SECTION 96 (1A) MODIFICATION APPLICATION DA16/0519- PROPOSED HOTEL, ST MARY'S RUGBY LEAGE CLUB.

SA6207_SMRLC_Hotel s96_Final_v2

- Figure 1 – Amended Carparking Plan (DA003)

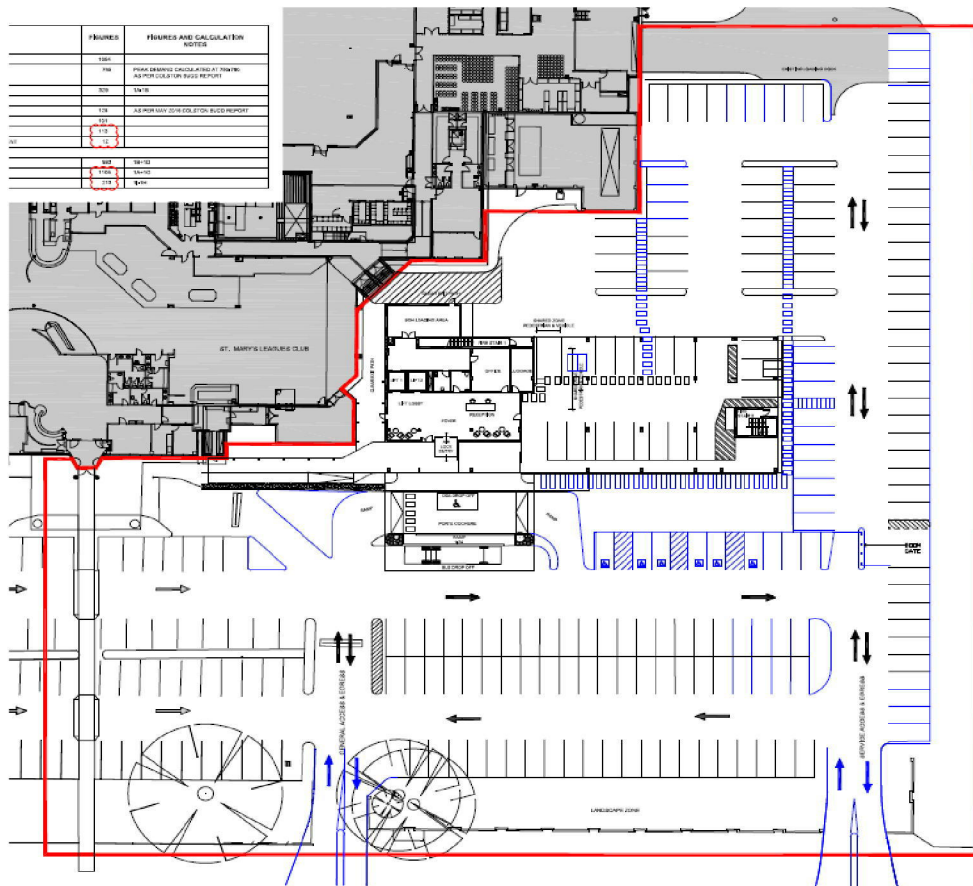
- Revise the approved car parking layout and rationalise the number car parking spaces associated with the hotel which will result in 12 additional car parking spaces to the to the overall number of car parking spaces for the site prior to the approval of D16/0519;

- Demolish and relocate the existing eastern driveway approximately 58.8m to the west to provide dedicated service vehicle access point ('The Eastern Driveway'). The Eastern Driveway will provide a new cross-over to Boronia Road to access to the internal site circulation and back of house areas and;

- Convert the approved central 'egress only' driveway ('The Central Driveway') to a two-way driveway for service vehicle, bus entry and general vehicle exit to Boronia Road This driveway will provide access to the general club parking in the south-east corner of the site, the hotel designated parking on the eastern side of the site and access to the 'Port Cochere' located at the club/hotel entrance.

- Relocate the approved boom gate to control access to dedicated hotel parking and back of house service areas for SMRLC.
- Improvements to the pedestrian access through the car park consisting of raised pedestrian crossings & extension to pedestrian path to meet Boronia Road footway. New kerbs and driveway median strips are also proposed to facilitate two-way entry and egress to both driveways.

- Minor changes in the approved water quality management strategy which proposes to provide 5 x 310mm ZPG Stormfilter cartridges in addition to existing site treatment devices.

- Minor increase in height to the approved parapet by 200mm. This will increase screening to any visible lift and roof plant equipment which consistent with Condition 12 of the consent, which states:

The proposed amendments are outlined in Figure 1 below:
